**PLANNING COMMISSION
NOTICE OF DECISION**

File No.: SMF2011 0001

Application For: Final Plat for Vista Del Sol subdivision – a major subdivision of 24 lots
(originally proposed as 25 lots)
Legal Description: Vista Del Sol Lot 1 (VDS Phase I)
Property Address: Glacier Highway
Parcel Code No.: 5-B14-0-101-002-3
Hearing Date: June 26, 2012

PROPOSAL: Final Plat for Vista Del Sol subdivision - a major subdivision of 24 lots (originally proposed as 25 lots)

PLAT OF
**VISTA DEL SOL SUBDIVISION
PHASE II**
A SUBDIVISION OF
**LOT 1, VISTA DEL SOL
SUBDIVISION PHASE I**
WITHIN U.S. SURVEY NO. 1568
CITY & BOROUGH OF JUNEAU, ALASKA
JUNEAU RECORDING DISTRICT

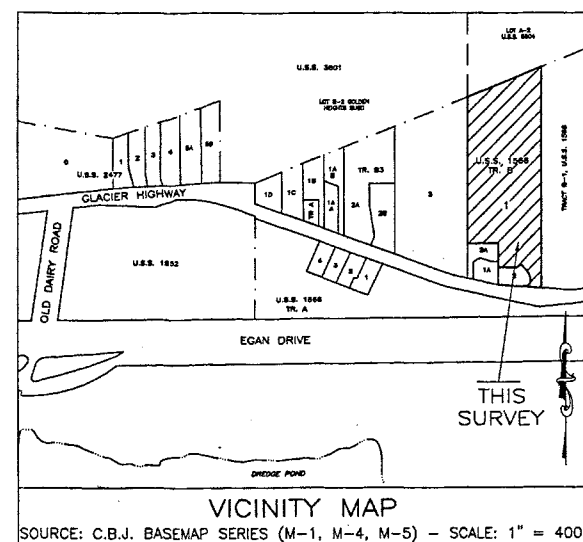
A plat note cannot supersede a process outlined in the Land Use Code. While the applicant may petition in the future for this street vacation, a note on the plat cannot automatically vacate the street after a certain period of time. Staff recommends removal of this note as it is inconsistent with the Land Use Code.

It should be noted that this plat note was included on the preliminary plat that was approved in 2008; however, the revised plat that included this note was submitted approximately a week before the public hearing. The staff report that accompanied this version of the final plat does not address this note; in fact, the staff report discusses the requirement of the connection to the adjacent property and the importance of street connectivity. This preliminary plat was on the consent agenda and therefore this discrepancy with this issue was not discussed at the public hearing. Regardless of this, a plat note cannot supercede procedural requirements as codified in the Land Use Code. Staff recommends the removal of this note from the final plat before recording.

2. Note 6 must be removed from the final plat. The final plat will not be recorded until this note is removed from the plat.
3. Note 5 will be revised to state the following: ***Vista Del Sol Subdivision Phase I access and utility easement vacated Deed Book XXX, Page XX and dedicated as right-of-way this plat.***
4. Preliminary plat (SUB2008-00014) conditions No. 3 and No. 4 are no longer required to be met per the EPA letter dated November 1, 2011.
